Office Action Summary	Application No. 10/579,146	Applicant(s) MAHONEY ET AL.
	Examiner Larry E. Waggle, Jr	Art Unit 3775

DETAILED ACTION

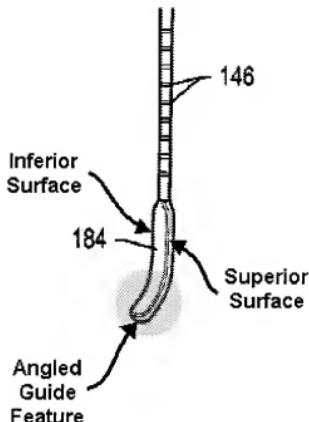
Webb discloses a surgical instrument system (Figures 13A-13D) comprising an instrument (182) capable of maintaining a distraction between vertebrae including a shaft (186) and a paddle (184) having inferior and superior surfaces (see annotated Figure below) located on a distal end of the shaft; an implant inserter (210; i.e. inserts the implant into final position as shown in Figure 13D) having a distal end (i.e. tip 212); and an access port (paragraph 0081), wherein the paddle and shaft present a guide surface (i.e. left surface of 184 as shown in Figure 10) and a guide feature (i.e. left surface of 186 as shown in Figure 10) for guiding the placement of the implant and interaction with the distal end of the inserter and an angled guide feature (see annotated Figure below) integral with the distal portion of the paddle to guide an implant (100) through a partial rotation to a desired angle and the paddle includes a first height (i.e. width of left surface of 184 as shown in Figure 10) and a second height (i.e. thickness of 184 as shown in Figure 13A) greater than the first height (Figures 10-13D and paragraphs 0072-0090). Further, the implant inserter includes a corresponding feature (i.e. right portion of 212 as shown in Figure 13C) capable of mating with the guide surface.
